March 9, 1998

HL-5579

Edwin I. Hatch Nuclear Plant  
Request for Additional Information on  
Extended Power Uprate License Amendment Request

Edwin I. Hatch Nuclear Plant  
Request for Additional Information on  
Extended Power Uprate License Amendment Request

Figure 40-1

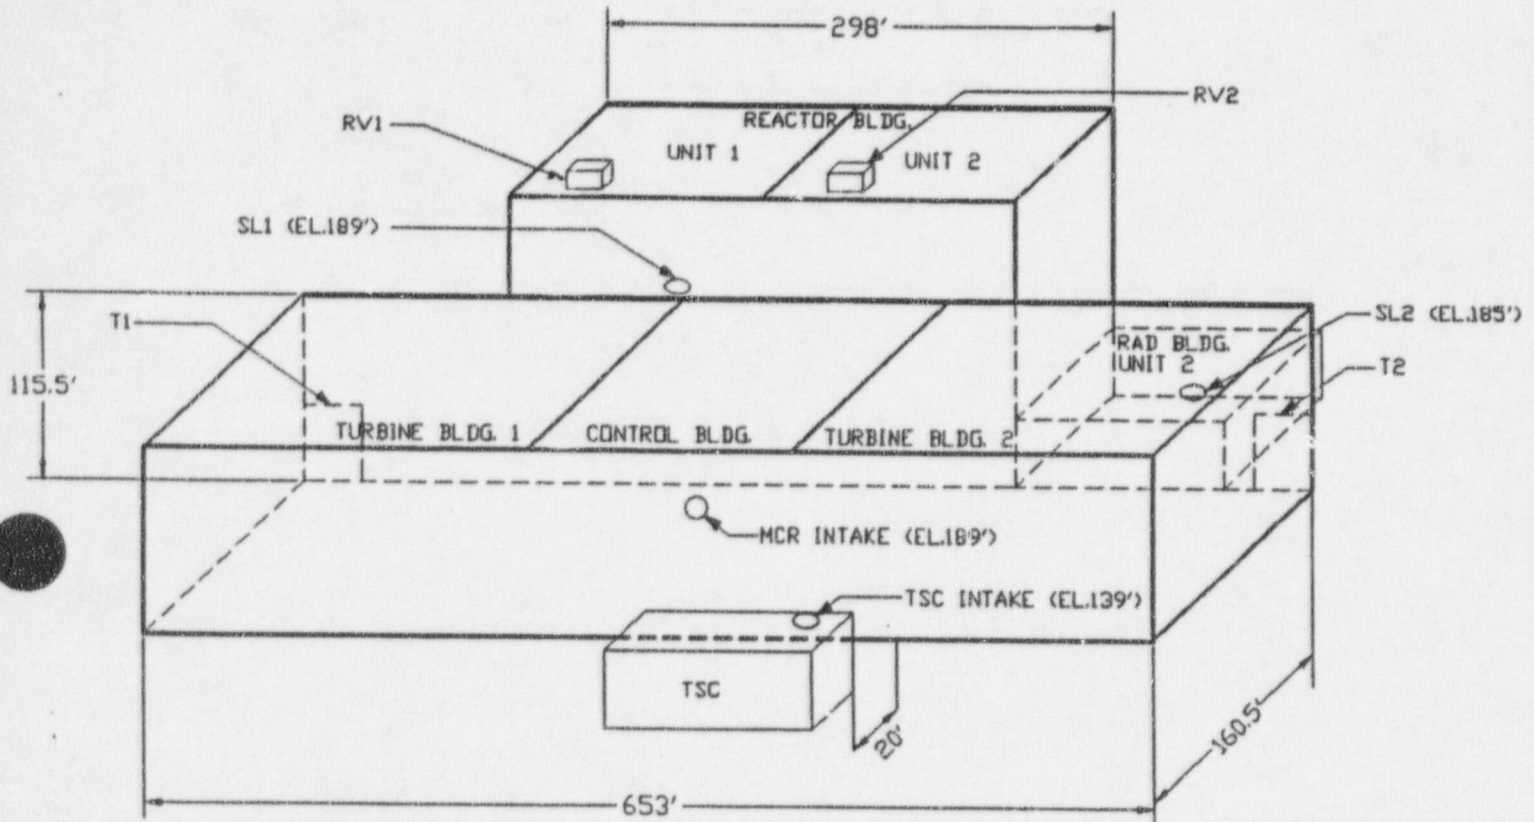
The Turbine Building railroad doors (T1 and T2 on Figure 40-1) are located on the east side of the building near each corner (approximately five feet from the building's corners) on the opposite side of the building from the MCR air intake location. It was assumed that the leakage through the doors would travel over the turbine building and into the wakes at the lee side of the building. This assumption yields a

The TB supply louvers (SL1 and SL2 on Figure 40-1) are located at approximately the same elevation as the MCR air intake. Therefore, the shortest path for releases from the louvers to the air intakes would be over the TB roof, following the roof contour, and downward towards the MCR air intake. Following this path, horizontal and vertical distances between the louvers and the MCR air intake were accounted for as a part of the total distance between the louvers and the intakes.

Figure 41-1  
 Plant Hatch 10m Wind Rose  
 1995

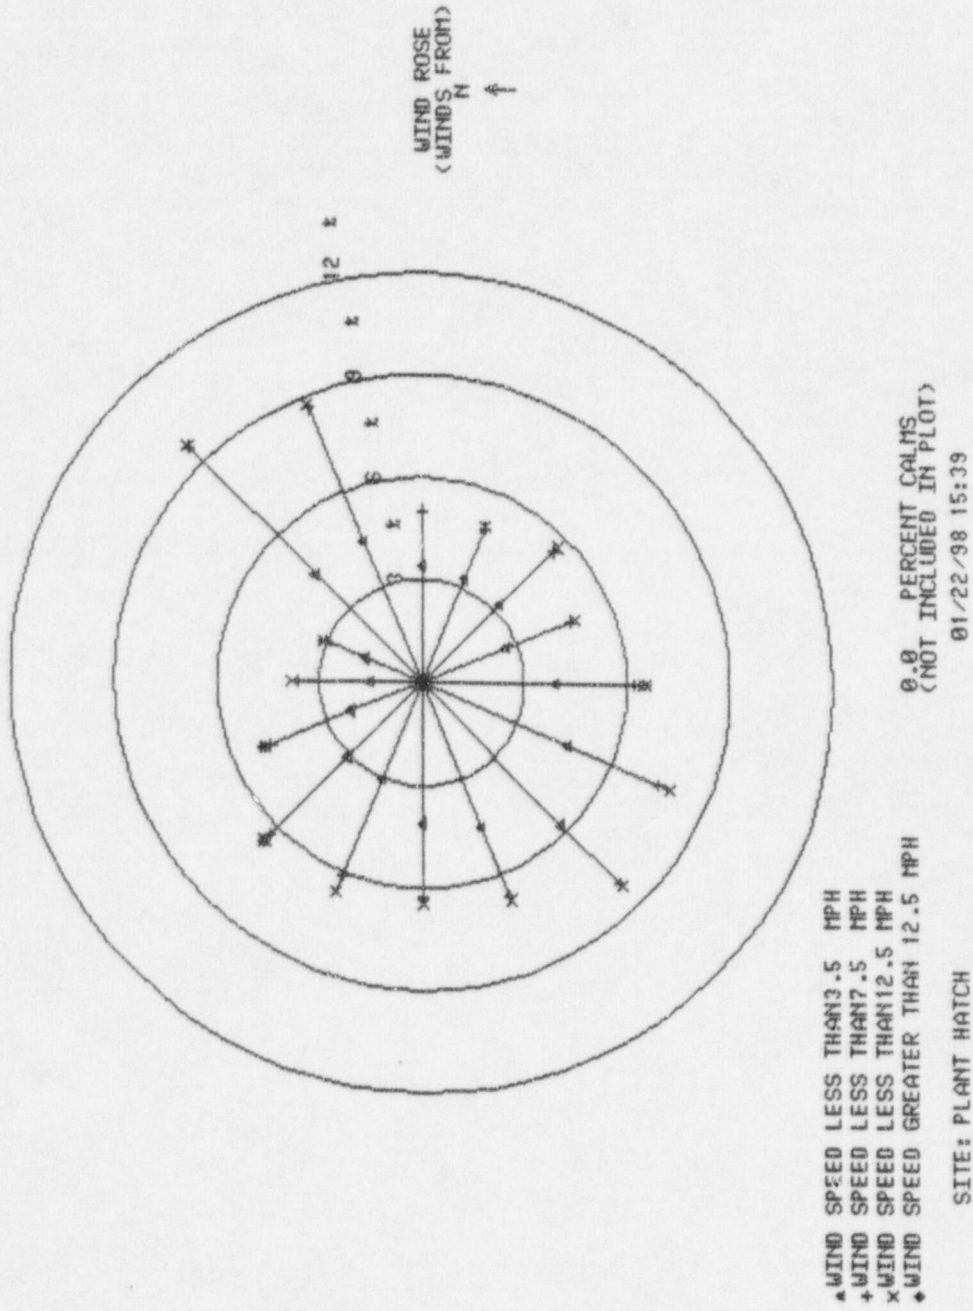
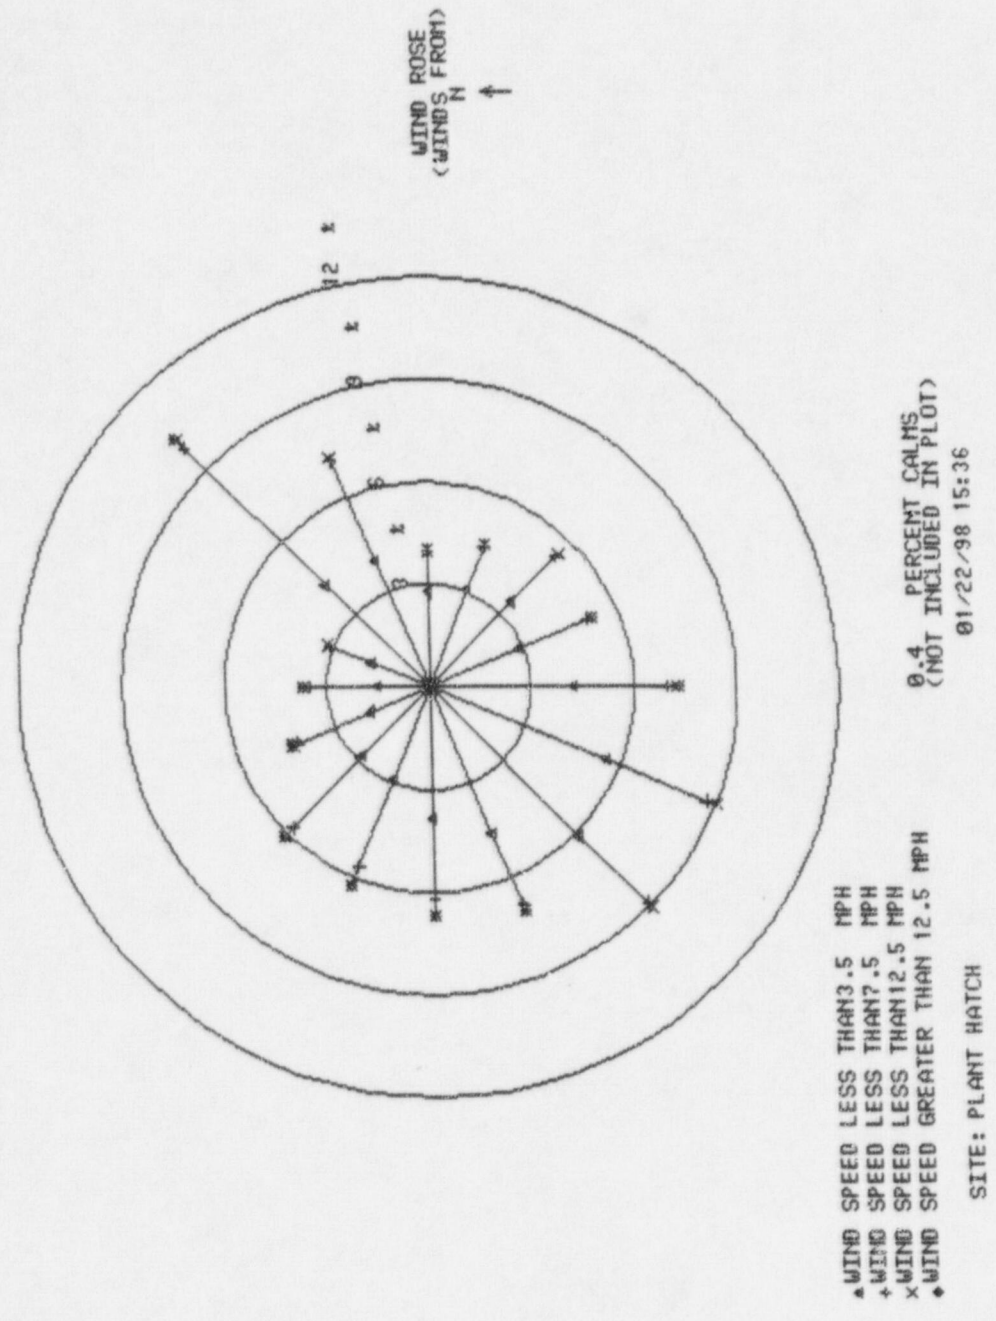
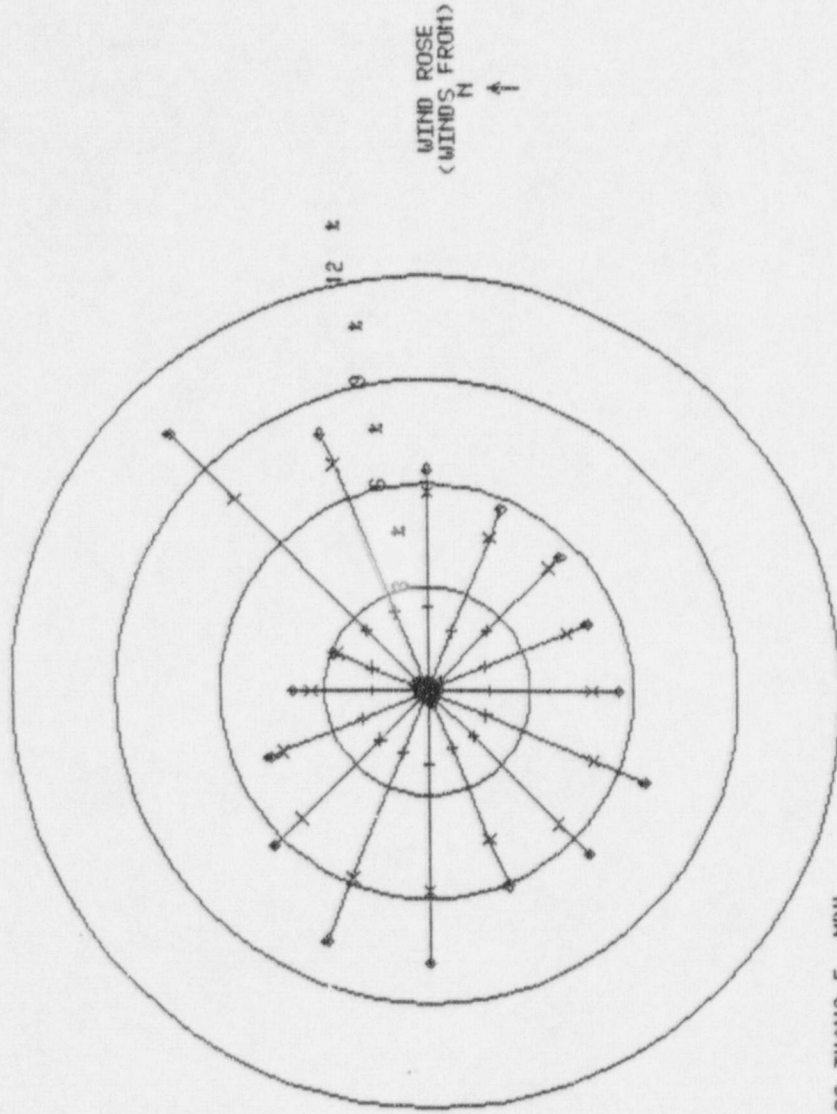
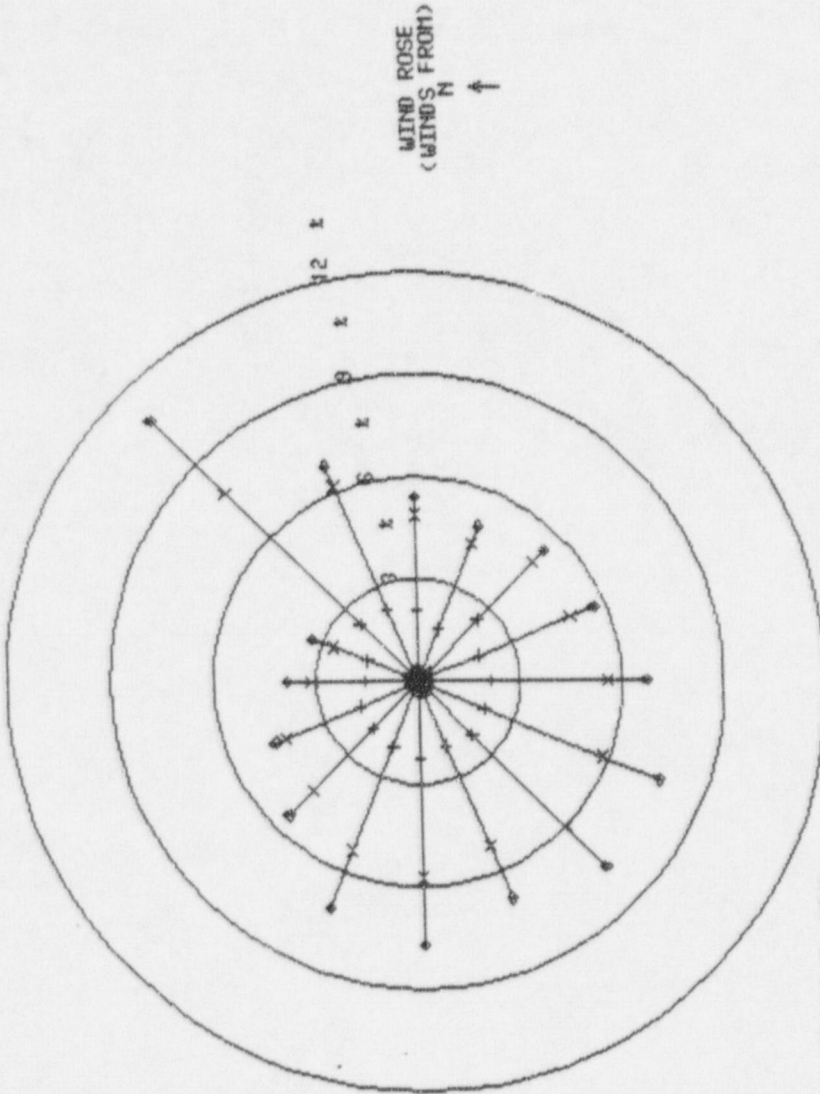
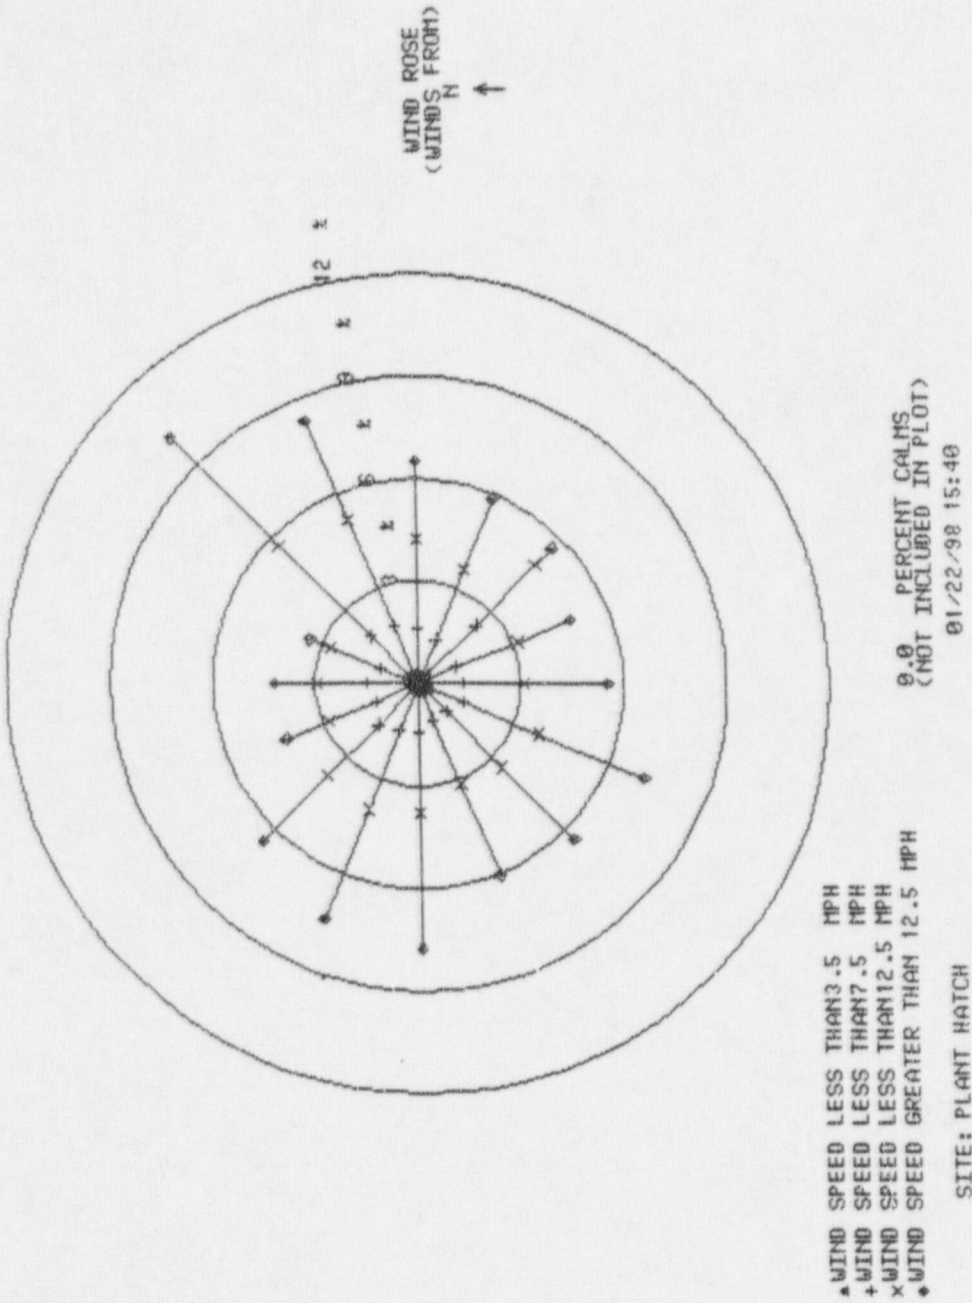
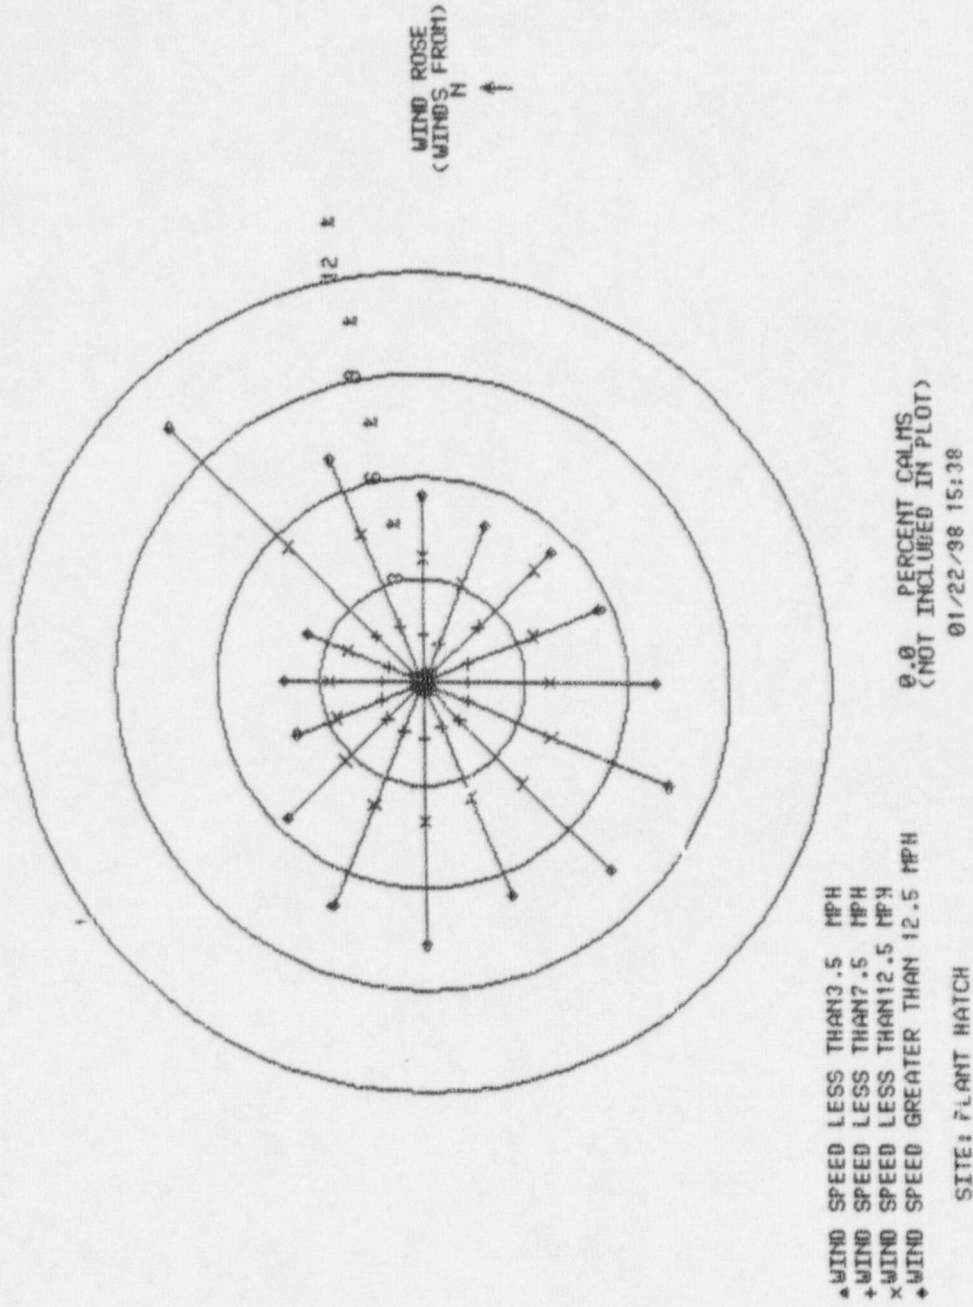
The wind directions have also been very consistent over the years of meteorological tower operation. The peak direction is typically from the northeast at all levels on the meteorological tower with secondary peaks from the southwest to the west. Figures 41-1 through 41-6 show wind roses for two periods, 1995 and 1994-96, and for each level (10, 60, 100m) on the Plant Hatch meteorological tower.
